Pulse Memorial

Conceptual Design

Workshop

December 12, 2024

Site Organization Option 1

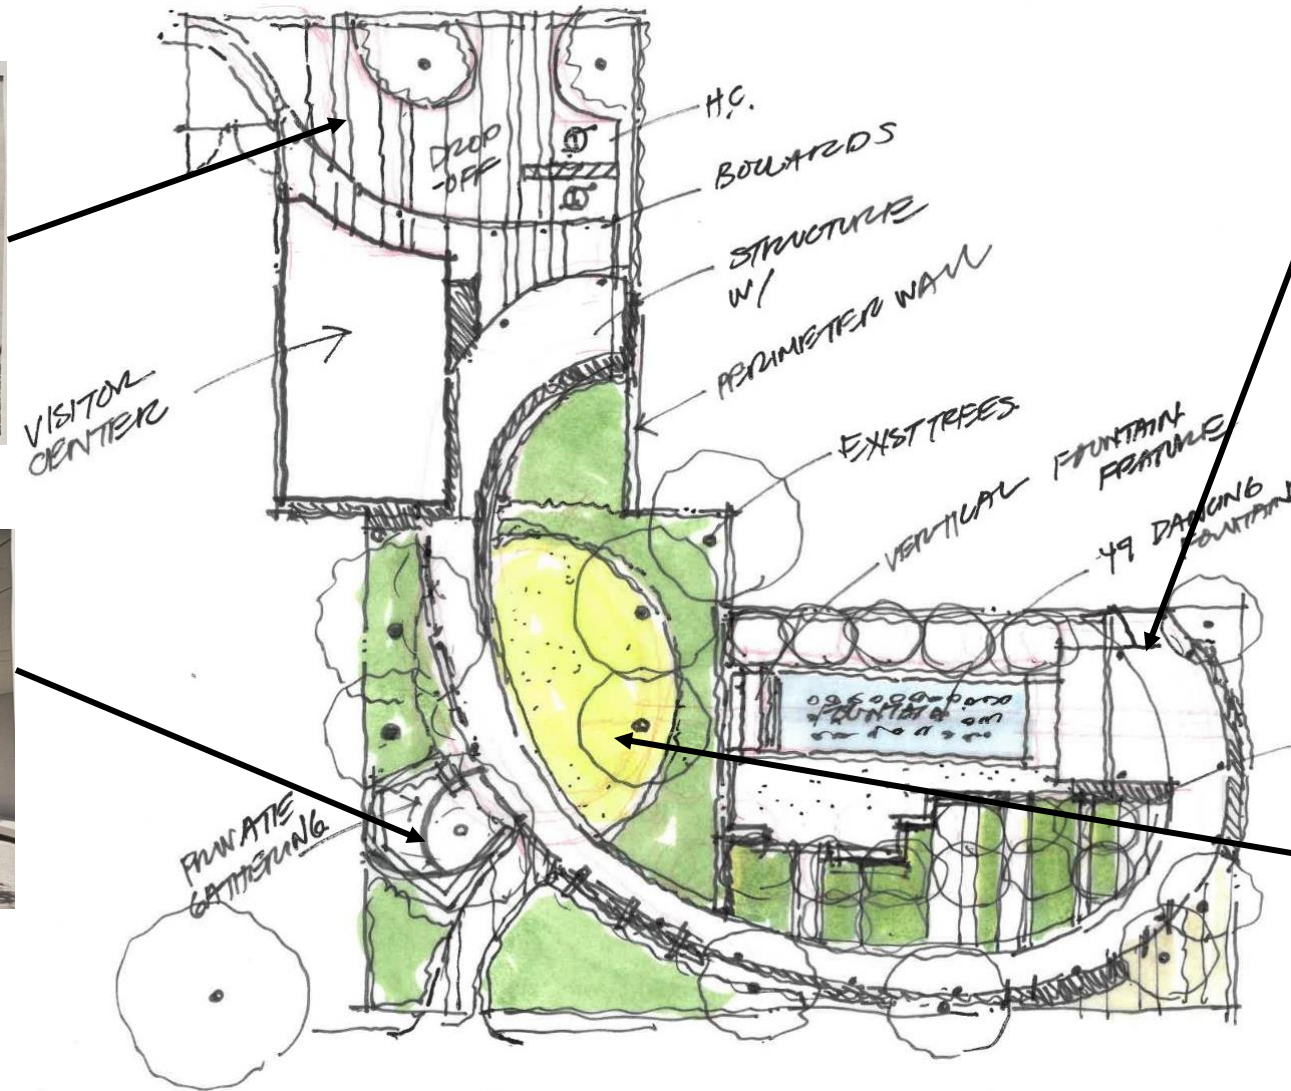
Option 1 Comments

- Ties everything together well
- colors in the ring or on the columns
- Option 1 seems more beautiful
- too grandiose for intimacy
- 4 (Private Gathering Area) speaks the most
- like that you kept the schematic outline of the building - Maybe outline the floor plan in rainbow mosaic
- I do like the 49 (columns)
- I don't think I would want names on those (Orange Avenue) columns
- fountains are too reminiscent of theme parks.
- like the placement of the privacy gathering
- could we include nationalities
- like the flag or something similar next to the name
- I do like the garden and the path

Site Organization Option 2

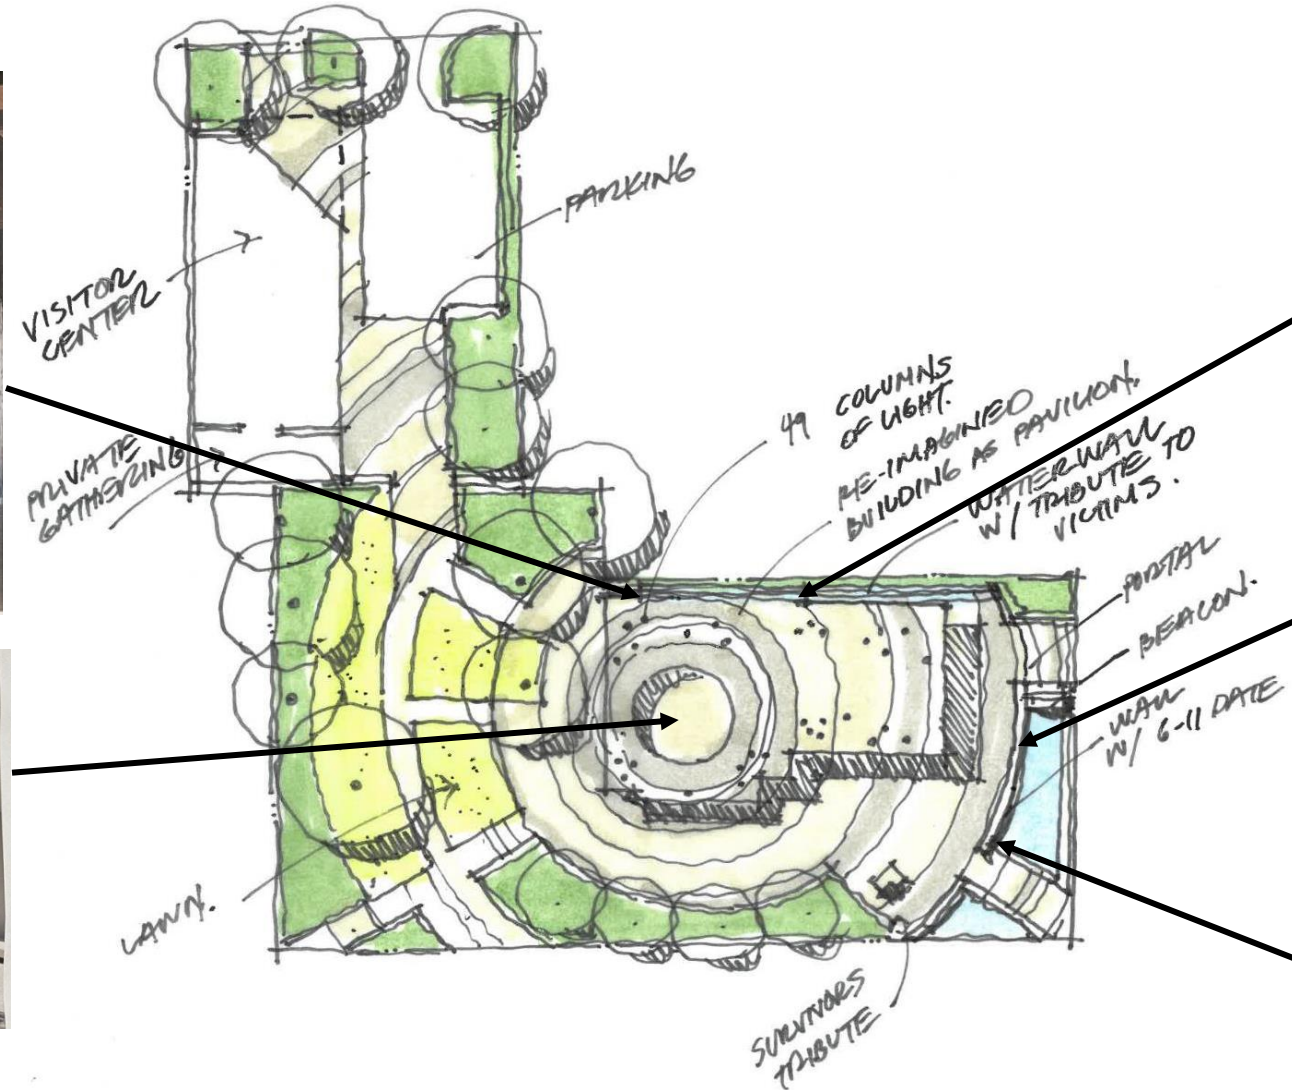
Option 2 Comments

- Dignified, more of a memorial feel, inspires hope, change
- I like the idea of the shoes
- Appreciate keeping the floorplan as the pavilion
- I did not like Option 1. I love Option 2
- As Latins we celebrate with music. If there is a funeral, or a celebration, there is music.
- Need a small monument for each one who was killed. for when family members go there, Could we place a capsule there, with objects given by the family members, under a plaque Bringing in something spiritual. I think that is missing
- The Pulse sign was something that stayed lit for years after the tragedy...I would love to see the sign stay.

Site Organization Option 3

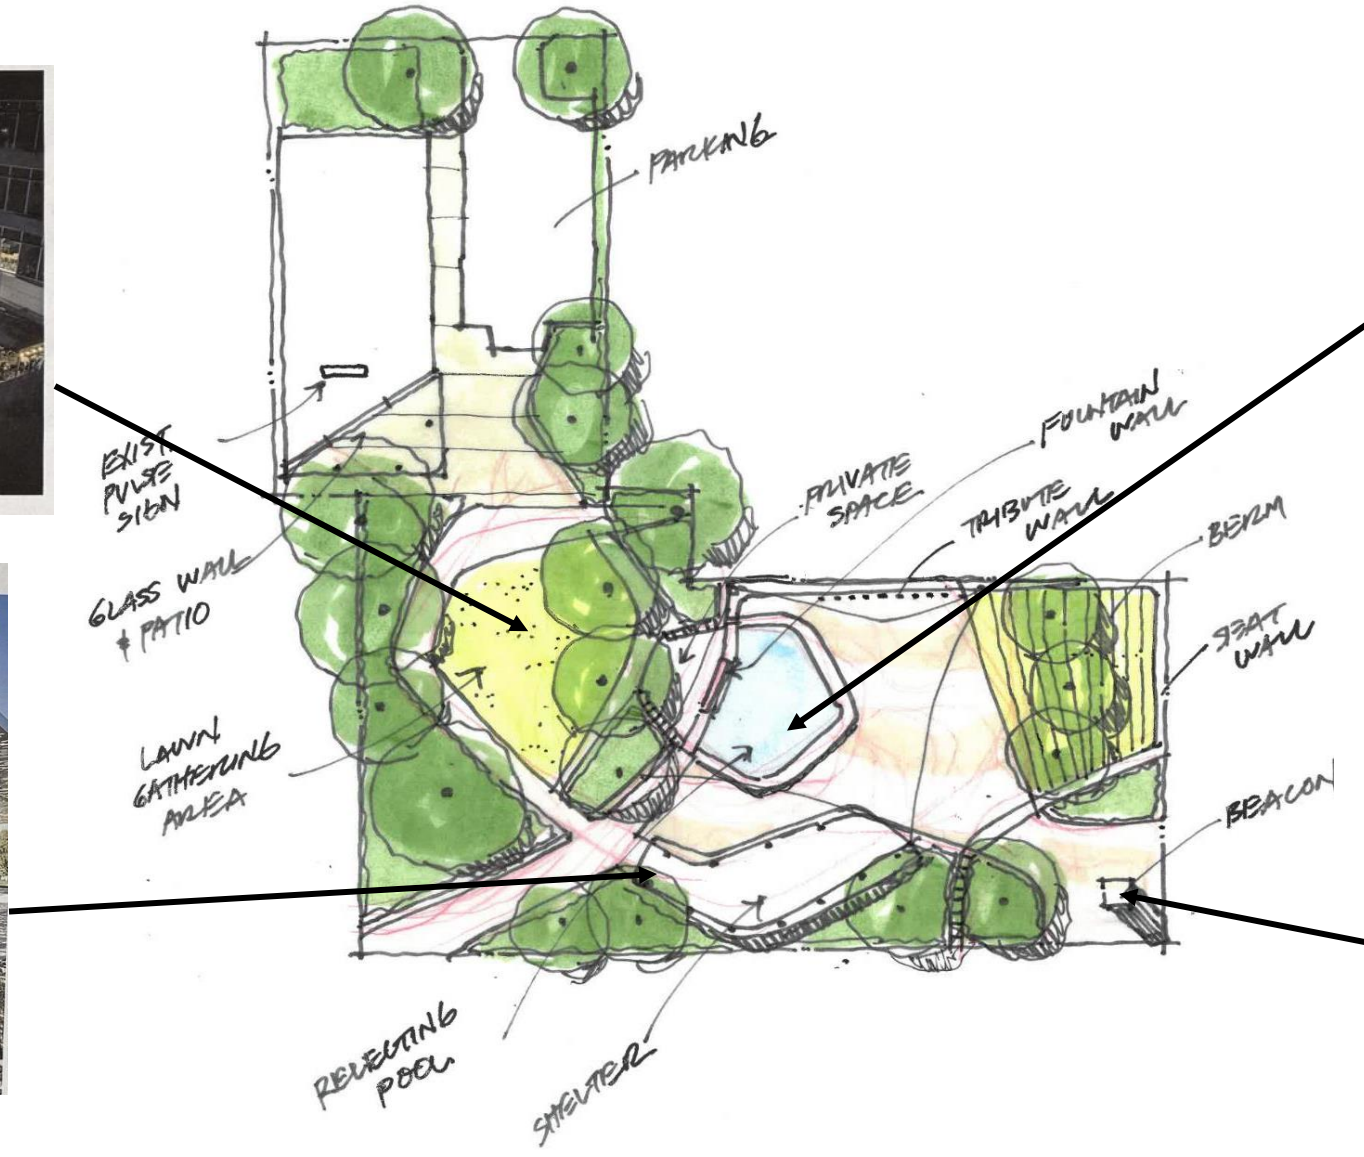
Option 3 Comments

- I do like the glass element
- Reminds me of a park (not in a good way).
- Would like to relocate the Pulse sign to that corner
- Regarding the objects from the families....it would take time to contact the families and get the objects. I love the ideas, but we would have start right now.
- What I like about this design is that it changes the landscape. I like that you know there is a memorial from a distance. It will become an icon of that street. All of the options should have that quality
- I like the art element
- The preservation of the building, there is so much symbolism, as you heard, it is sacred. If parts can be kept and covered, or sealed in, I would like that....I think it would be meaningful to keep them within the site
